Objection

Planning Application Ref: HGY/2021/2703 44-46 Hampstead Lane

Erection of dementia care home (Use Class C2) with subterranean car park, following demolition of existing dwellings

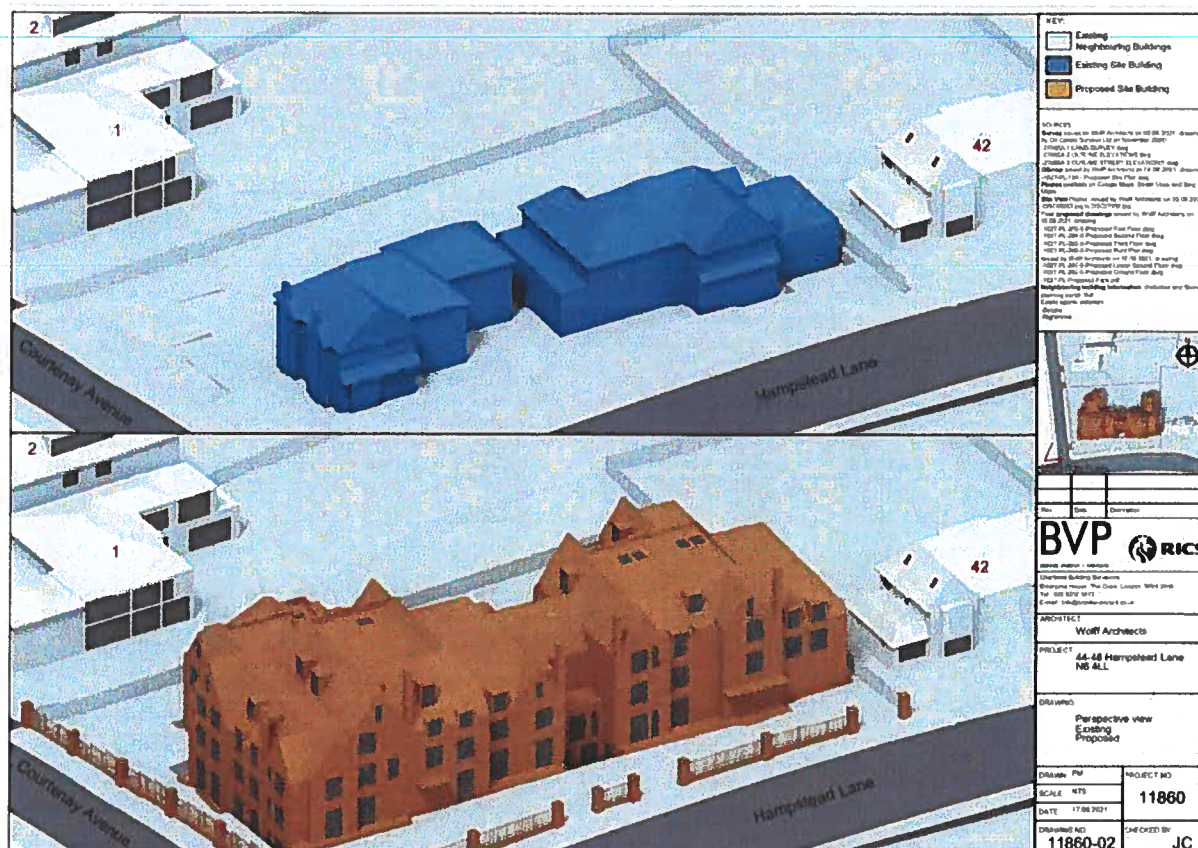
As can be seen from the image below, which has been taken from the applicants Daylight and Sunlight Report, the proposed scheme comprises a much larger scheme than what is existing at the site:

The proposals comprise a scheme that is much larger, taller, bigger and bulkier than the existing buildings and would be completely out-of-character with the surrounding area. The footprint, height and bulk of the development are such that it would give much more enclosed feeling to users of the area, against policy DH2, DH10 and the Conservation Area Statement and if consented, it would have a detrimental impact on the character of the Conservation Area and neighbourhood.

If, as the applicant claims it is not possible to retain the existing buildings and retaining the use of the site for residential is not viable, any replacement scheme should be that of which is much of in keeping with the existing buildings in terms of size, scale and footprint and respectful of Highgate Conservation Area.
